SERVICE BULLETIN

APPLICABILITY: 2014MY XV Crosstrek Hybrid (HEV)

NUMBER: 07-87-14

SUBJECT: Design Change of Rear Combination Lamps to Prevent Fogging and Condensation

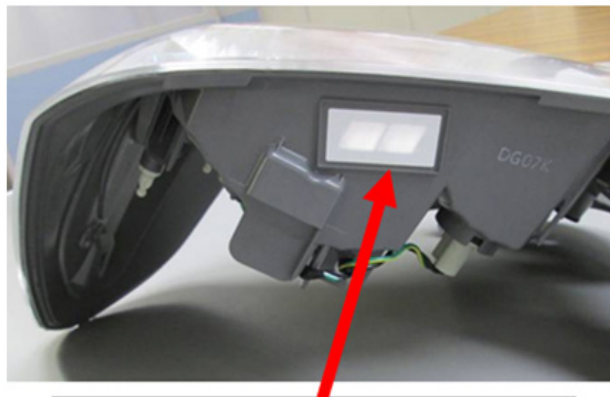
This bulletin provides information regarding design changes to the rear combination lamp assembly to prevent fogging and accumulation of condensation. These changes involve:

- An Anti-Fog coating is now applied during production to the inner surface of the outer lens.

Anti-Fog coating applied on the inner surface of the outer lens.

- Additional ventilation added to the bottom portion of the housing.

Additional ventilation added.

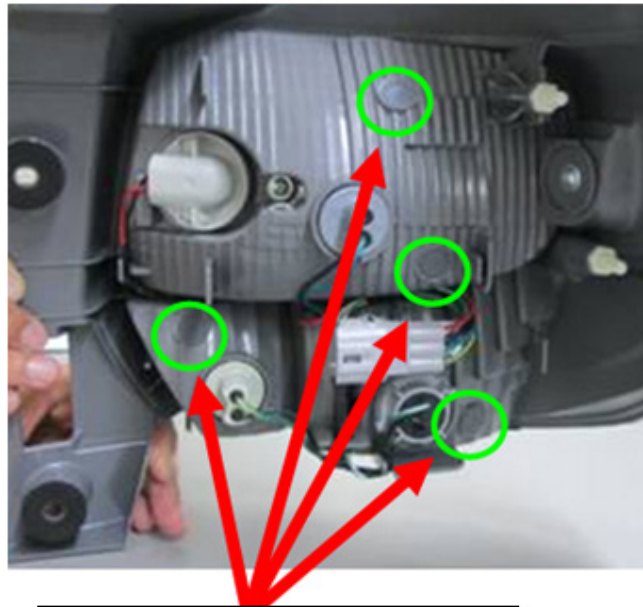
- Revised shape and locations for the 4 existing ventilation holes.

Shape and locations of 4 ventilation holes changed.
